<b>Product/Process Change Notice (PCN)</b>														
<input type="checkbox"/> Major Change <input checked="" type="checkbox"/> Minor Change														
<b>PCN Number:</b> PCN_FrqXTAL_20250308  <b>Affected Series:</b> WE-XTAL  <b>Affected Part Number:</b> 830002995B, 830002996B, 830002997B, 830014219B  <b>PCN Date:</b> 2024-12-06 <b>Effective Date:</b> 2025-03-08	<b>Change Category:</b> <input type="checkbox"/> Equipment/Location <input checked="" type="checkbox"/> General Data <input type="checkbox"/> Material <input type="checkbox"/> Process <input type="checkbox"/> Product Design <input type="checkbox"/> Shipping/Packaging <input type="checkbox"/> Supplier <input type="checkbox"/> Software													
<b>Contact:</b> Product Management  <b>Phone:</b> +49 (0) 7942 - 945 5001  <b>Fax:</b> +49 (0) 7942 - 945 5179  <b>E-Mail:</b> pcn.eisos@we-online.com	<b>Datasheet Change:</b> <input checked="" type="checkbox"/> Yes <input type="checkbox"/> No  <b>Attachment:</b> <input type="checkbox"/> Yes <input checked="" type="checkbox"/> No

<b>DESCRIPTION OF CHANGE:</b> Because of a database mismatch, Würth Elektronik eiSos will correct the RoHs status (1), Electrical parameters (2), p

3. Correction of the Product Dimensions:

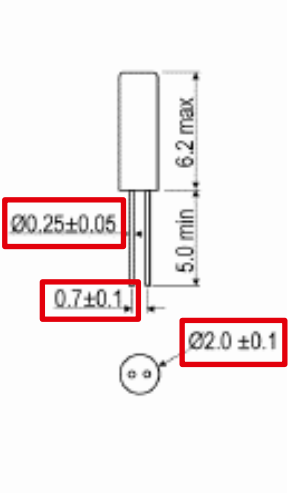
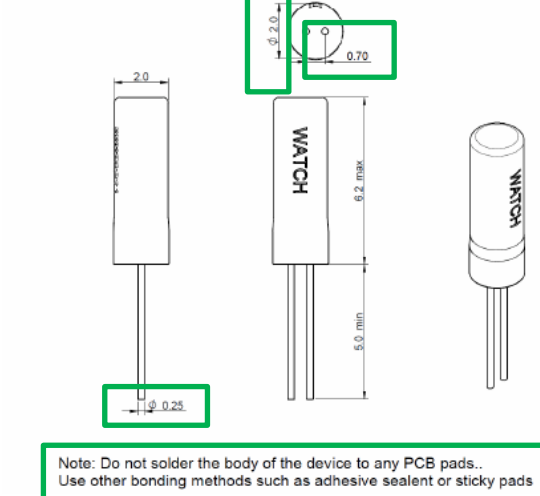
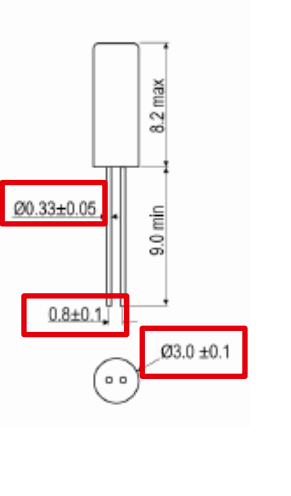
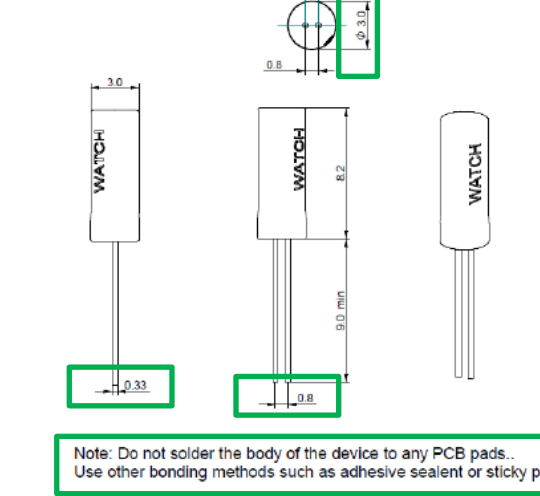
Affected Part Numbers	Before	After
Product Dimensions	830002997B, 830014219B		 <p>Note: Do not solder the body of the device to any PCB pads.. Use other bonding methods such as adhesive sealent or sticky pads</p>
	830002995B, 830002996B		 <p>Note: Do not solder the body of the device to any PCB pads.. Use other bonding methods such as adhesive sealent or sticky pads</p>
